Subject: UniStar Nuclear Energy, NRC Docket No. 52-016
Calvert Cliffs Nuclear Power Plant, Unit 3
RAI No. 1012, Design Basis Accidents
RAI No. 1013, Nuclear Waste Policy Act Status

Responses to NRC Requests for Additional Information

Calvert Cliffs Nuclear Power Plant Unit 3

**Table 7.1-13—{Summary of DBA Radiological Consequences of Offsite Receptors
 Form CCNPP Unit 3}**

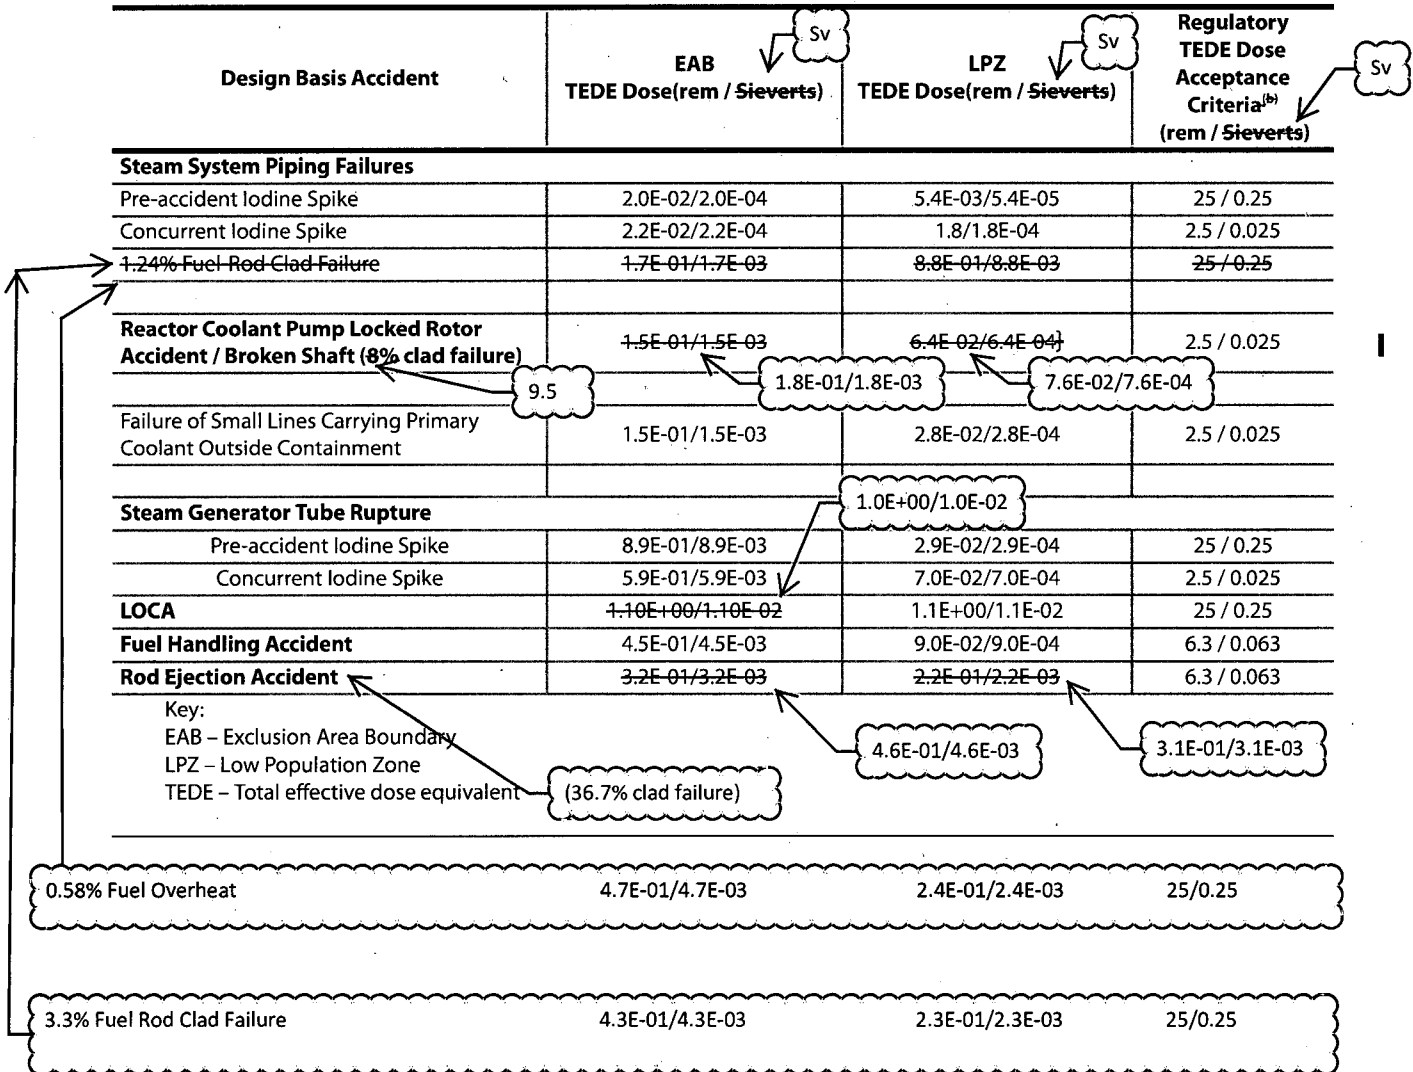
- 1) The Locked Rotor accident source term in the RAI response No.147 postulates 8% clad failure. However, the DCD Tier 2 section 15.0.3.8 presents dose estimates for 9.5% clad failure.
- 2) The Rod Ejection accident source term in the RAI response No.147 postulates 26% clad failure. However, the DCD Tier 2 Table 15.0-44 and Section 15.0.3.9 presents dose estimates for 36.7% clad failure.
- 3) RAI response No.147 provides source terms for the Main Steam Line Break (MSLB) accident that are inconsistent with the DCD. The differences are (a) the ER includes a source term for the MSLB with 1.24% clad failure, but the DCD does not analyze this case; and (b) the DCD in Tier 2 Section 15.0.3.7 and Table 15.0-34 analyzes the MSLB with 3.3% clad failure and 0.58% full-rod fuel melt, but the ER does not provide source terms for these cases.

The listed atmospheric releases for the Steam System Piping Failure (Table 7.1-16), Pump Locked Rotor Accident (Table 7.1-17) and Rod Ejection Accident (Table 7.1-23), with clad failure and fuel overheat (as applicable), have been revised to correspond to the DBA scenarios in US EPR FSAR Chapter 15.0 with maximized fuel damage selected to yield 90% of the dose acceptance criterion at the critical receptor.

Design Basis Accident	EAB TEDE Dose(rem / Sieverts)	LPZ TEDE Dose(rem / Sieverts)	Regulatory TEDE Dose Acceptance Criteria ^(b) (rem / Sieverts)
Steam System Piping Failures			
Pre-accident Iodine Spike	2.0E-02/2.0E-04	5.4E-03/5.4E-05	25 / 0.25
Concurrent Iodine Spike	2.2E-02/2.2E-04	1.8/1.8E-04	2.5 / 0.025

1.24% Fuel Rod Clad Failure	1.7E-01/1.7E-03	8.8E-01/8.8E-03	25/0.25
Reactor Coolant Pump Locked Rotor Accident / Broken Shaft (8% clad failure)			
	1.5E-01/1.5E-03	6.4E-02/6.4E-04	2.5 / 0.025
Failure of Small Lines Carrying Primary Coolant Outside Containment	1.5E-01/1.5E-03	2.8E-02/2.8E-04	2.5 / 0.025
Steam Generator Tube Rupture			
Pre-accident Iodine Spike	8.9E-01/8.9E-03	2.9E-02/2.9E-04	25 / 0.25
Concurrent Iodine Spike	5.9E-01/5.9E-03	7.0E-02/7.0E-04	2.5 / 0.025
LOCA	1.10E+00/1.10E-02	1.1E+00/1.1E-02	25 / 0.25
Fuel Handling Accident	4.5E-01/4.5E-03	9.0E-02/9.0E-04	6.3 / 0.063
Rod Ejection Accident	3.2E-01/3.2E-03	2.2E-01/2.2E-03	6.3 / 0.063
Key: EAB – Exclusion Area Boundary LPZ – Low Population Zone TEDE – Total effective dose equivalent

0.58% Fuel Overheat	4.7E-01/4.7E-03	2.4E-01/2.4E-03	25/0.25
3.3% Fuel Rod Clad Failure	4.3E-01/4.3E-03	2.3E-01/2.3E-03	25/0.25
